SERVICE BULLETIN MAINTENANCE OF WAY EQUIPMENT

DATE: 2-10-2006 **BULLETIN NO:** 06-001

TITLE: ENCODER ADAPTER PLATE CAP SCREWS IN DURST GEARBOXES

FIGURE 1
TYPICAL ENCODER MOUNTING IN DURST GEAR BOX
C Series Rail Grinder Illustrated

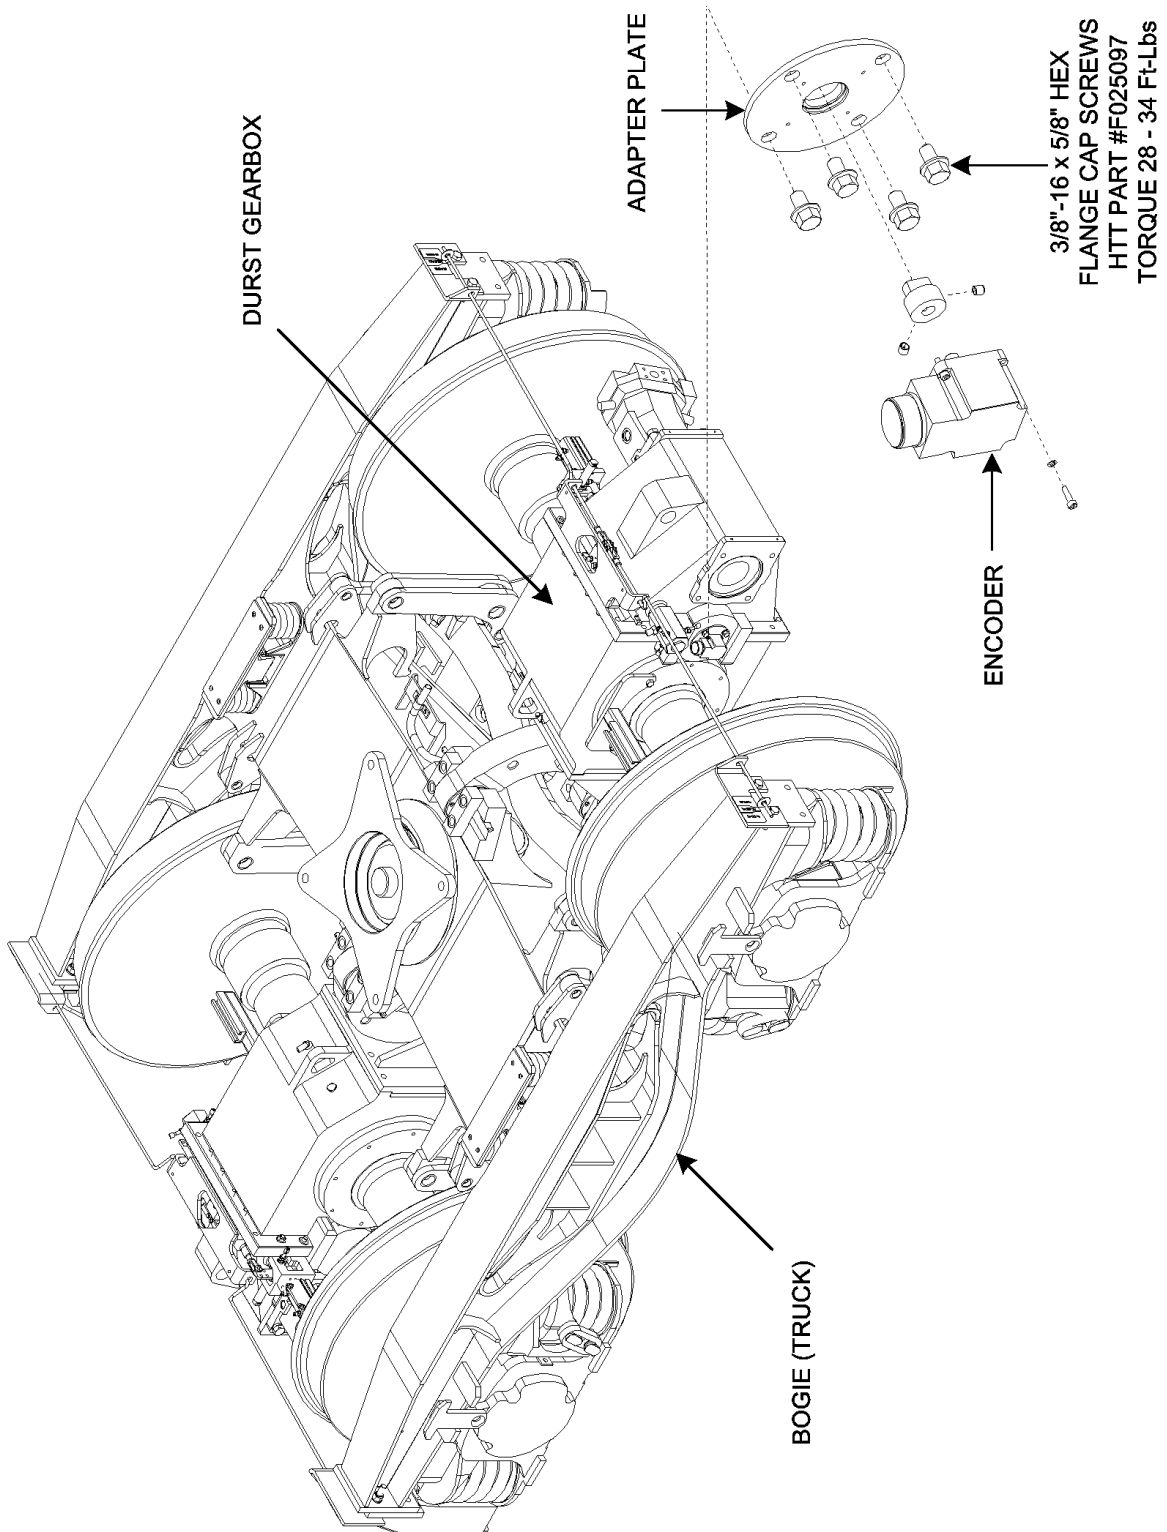
SUMMARY: The 3/8 inch cap screws that mount the encoder adapter plate to the Durst gearbox may be too long bottoming out in the tapped hole and interfering with the intermediate shaft roller bearing causing premature bearing failure. The correct cap screws that must be used are 3/8-16 x 5/8 inch hex flange cap screws (HTT part # F025097).

CHECKING CAP SCREW THREAD LENGTH - See Figure 1 and Figure 2

1. Locate the encoder on the side of each Durst gearbox.
2. Thoroughly clean the side of the Durst gearbox, encoder and adapter plate to remove all dirt, grease, debris, grinding dust, etc.
3. Remove the four 3/8 inch cap screws that mount the encode adapter plate to the side of the Durst gearbox.
4. If the cap screws are 5/8 inch long, it is not necessary to replace the cap screws.
5. If the cap screws are longer than 5/8 inch, replace the cap screws with 3/8-16 x 5/8 inch hex flange cap screws (HTT part # F025097).
6. Install the encoder adapter plate on the side of the Durst gearbox using the four 3/8-16 x 5/8 inch hex flange cap screws (HTT part # F025097). Torque the four cap screws to 28 - 34 ft-lbs.

**FIGURE 2
DURST GEAR BOX**

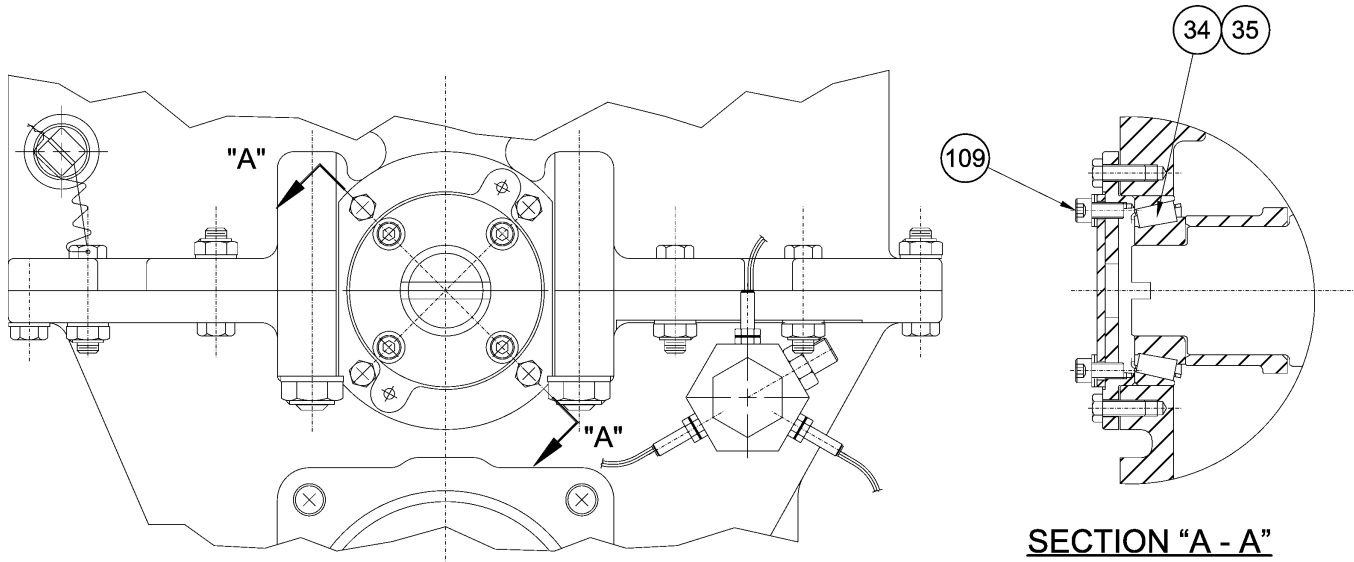
- 9. CAUTION: USE 3/8"-16 X 5/8" HEX FLANGE CAP SCREWS (HTT PART # F025097) (ITEM #109) TO LIMIT THREAD ENGAGEMENT DEPTH INTO INTERMEDIATE BEARING RETAINER (ITEM #34) BETWEEN 3/8 AND 1/2 INCH. THIS WILL PREVENT CAP SCREWS FROM INTERFERING WITH TAPER ROLLER BEARING (ITEM #35) OR BOTTOMING OUT IN TAPPED HOLE.
